Administrative Site Review

Case File / Name:	SR-13-14 / E-36 Elementary School
General Location:	This site is located on the south side of the intersection of Tarheel Club Road and Tarheel Clubhouse Road.
CAC:	Northeast
Request:	Development of a 21.5 acre tract zoned Agriculture Productive (AP) into a 102,100 square foot civic building. Proposed development will contain an elementary school with associated parking, recreational facilities, stormwater devices, and tree conservation areas. Parking will be provided at one space per five seats in the principal assembly room in accordance with Section 7.1.2.C. 132 spaces are required, 135 spaces are provided. The Traffic Impact Analysis has required offsite improvements to be made at the intersection of Old Milburnie Road and Tarheel Club Road. These improvements will be submitted under a separate Infrastructure Construction Drawing submittal from the school site. The

SR-13-14 Site Plan

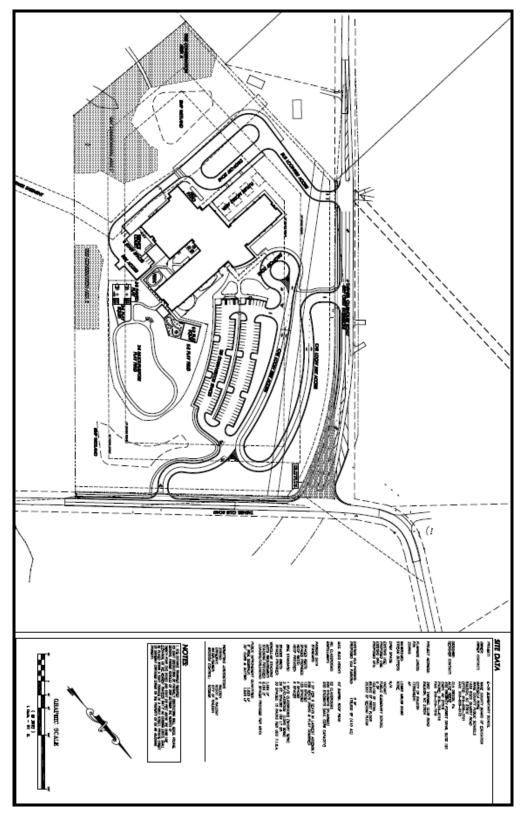
- That a stormwater control plan with a stormwater operations and maintenance manual and budget shall be approved by the Stormwater Engineer in compliance with Part 10A Chapter 9 of the Unified Development Ordinance, including the designation of buffer areas and open space areas for stormwater purposes prior to grading or the approval of construction drawings whichever event comes first;

- 2. That NCDENR approve and permit the sediment and erosion control plan for this development;
- 3. That a nitrogen offset payment must be made to a qualifying mitigation bank;

- 4. That the developer shall pay to the City a stormwater facility replacement fund payment equal to twenty-four percent (24%) of the estimated cost of constructing all stormwater control facilities shown on the development plans;

- 5. That in accordance with Part 10A Section 9.4.4, a surety equal to 125% of the cost of clearing, grubbing and reseeding a site shall be paid to the City;

- That all stormwater control measures and means of transporting stormwater runoff to and from any nitrogen and stormwater runoff control measures shall be shown on any plats for recording as private drainage easements;

- 7. That a final tree conservation plan with permit be approved by the Forestry Specialist. The plan must show metes and bounds descriptions of all tree conservation areas, and tree protection fence around all tree conservation areas. Tree protection fence must be located in the field and inspected by the Forestry Specialist;

- 8. That construction plans for the shared stormwater devices, public utilities, and public roadway improvements be submitted and approved by the Public Works Department;

- 11. That in accordance with Part 10A Section 9.2.2, a surety equal to 125% of the cost of the construction of a stormwater device is paid to the Public Works Department;
- 12. That the developer shall pay to the City a stormwater facility replacement fund payment equal to twenty-four percent (24%) of the estimated cost of constructing all stormwater control facilities shown on the development plans;
- 13. That in accordance with Part 10A Section 8.1.3, a surety equal to 125% of the cost of development related improvements is paid to the Public Works Department;
- 14. That right-of-way dedication on Tarheel Clubhouse Road and Tarheel Club Drive be recorded as shown on the approved preliminary plan.

- 15. That a tree conservation map be recorded with metes and bound showing the designated Tree Conservation Areas and shall be in compliance with Chapter 9 of the Unified Development Ordinance;
- 16. That the offsite sanitary sewer easement be dedicated to the City of Raleigh and the recorded map provided to the Planning Department.

- 17. That in accordance with Part 10A Section 9.2.2, an as-built plan and certification any stormwater control device shall be reviewed and accepted by the City prior to final stormwater inspection approval or certificate;
- 18. That construction drawings for the offsite roadway improvements be approved by the Public Works Department.
